SUBJECT	DATE
TS-940S VCO CARRIER TO NOISE RATIO IMPROVEMENT	3-2-87

The Carrier to Noise ratio of the TS-940S may be improved by the following changes. This bulletin supersedes bulletin number 911 dated September 15, 1986.

PLL UNIT

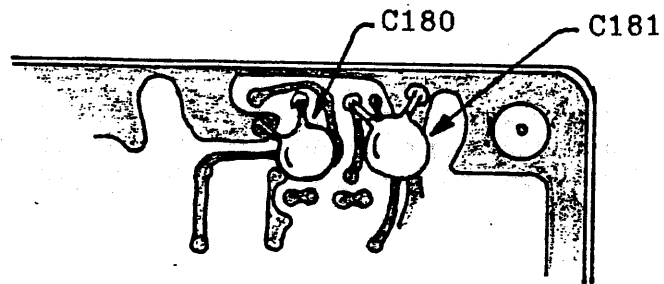
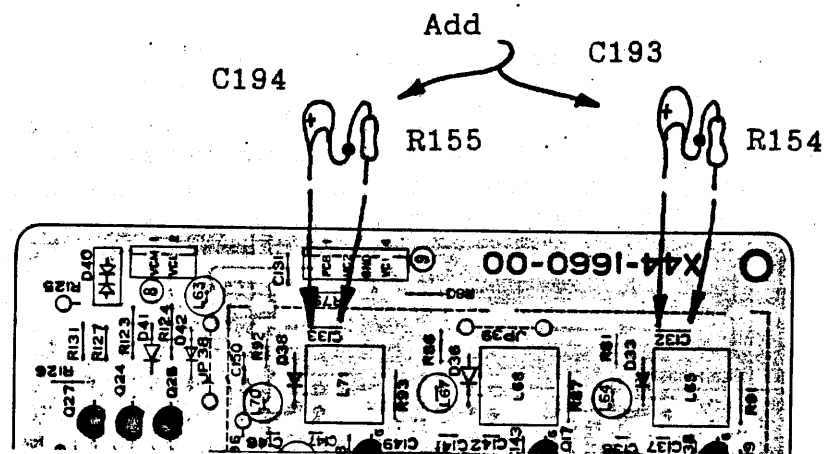
On the PLL UNIT (X50-2020-00) remove capacitors C176, C180, and C181. Change resistors R120 and R129 from 470 ohms to 3.3 K ohms. Change resistors R121 and R124 from 1 K ohm to 680 ohms. Change capacitors C184 and C185 from .22 uF to .33 uF 35V tantalum capacitors. Install C180 and C181 in the positions shown in the accompanying diagrams. The use of new capacitors is recommended to improve reliability, don't try to reuse the old capacitors! Capacitors C181 and C180 should be attached to the foil side of the PLL unit.

RF UNIT

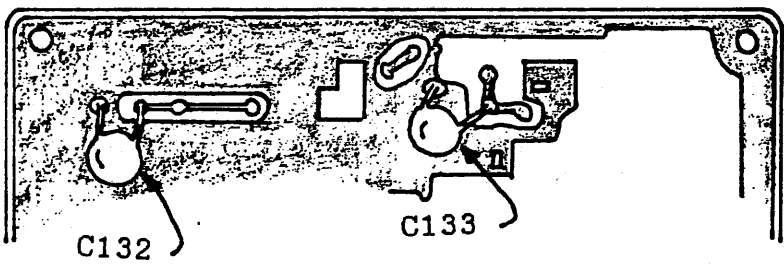
On the RF Unit (X44-1660-00) install the series RC circuits composed of R154 and C193, and R155 and C194, as shown in the accompanying diagrams. As the diagrams illustrate it is easiest to move C132 and C133 to the foil side of the board and install the series RC circuits on the component side.
